## Technical Brief

**Subject: Summary of Changes since Conceptual design review on February 17 2022**

**Proposed concept North elevation**

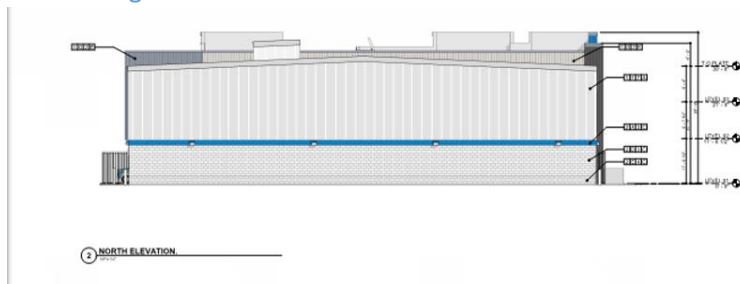
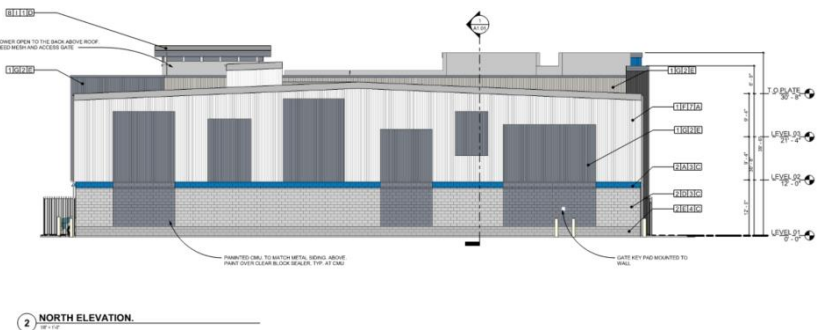
- Provided decorative and material changes to the North and West side of building by providing contracting materials.
